SERVICE INFORMATION

Bulletin Nbr: 771-2254

Adaptation of wheel housing to 17" wheels

Saab 9-3 CV model year 2000 with engine type B205R (200 hp).

D771B004

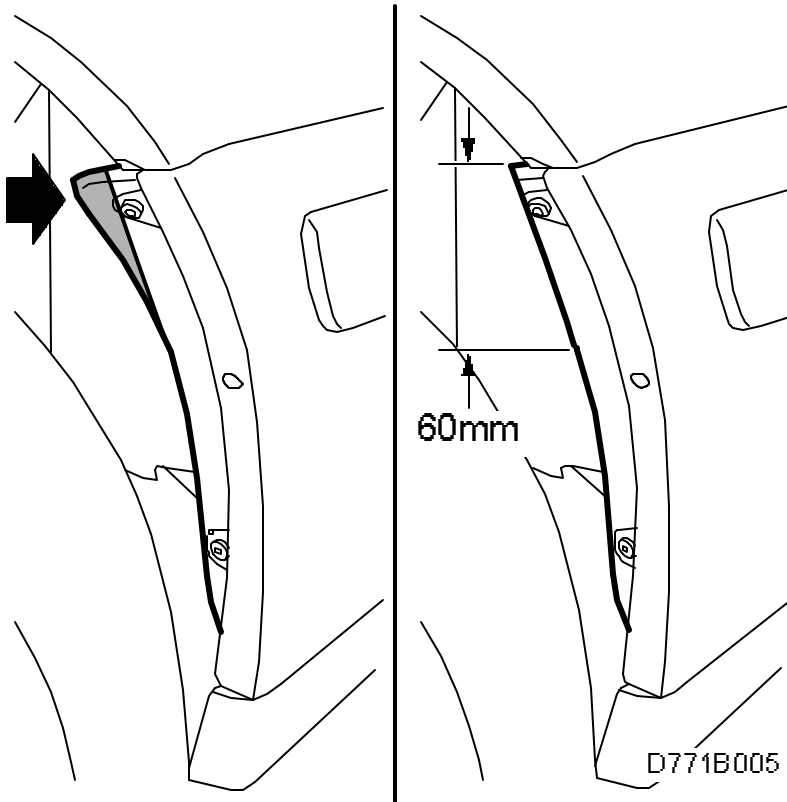
Upon maximum compression on the springs, when carrying heavy cargo for example, the wheels will scrape against two plastic nuts in the front wheel housing and a plastic corner on the rear bumper.

1. Grind or file off the corner of the rear bumper from the top edge down 60 mm. Grind the top end in to the rivet.

Be careful not to grind so much that the plate within the plastic is damaged.

D771B006

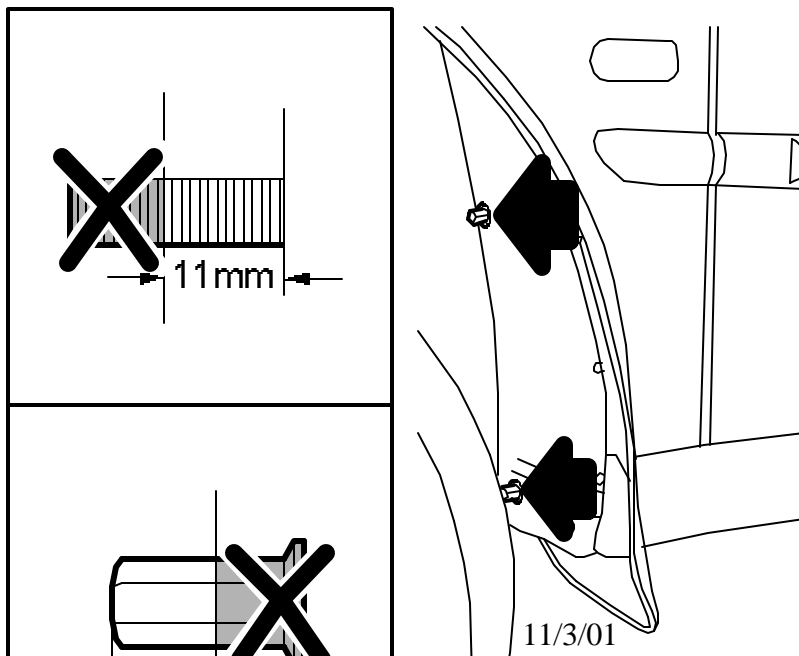
2. Remove the plastic nuts from the two lower bolts in the wheel housing behind the front wheel.

3. Cut the bolts to a max. length of 11 mm, measured from the metal of the body.
4. Grind the nuts to a length of 8 mm.
5. Refit the nuts.
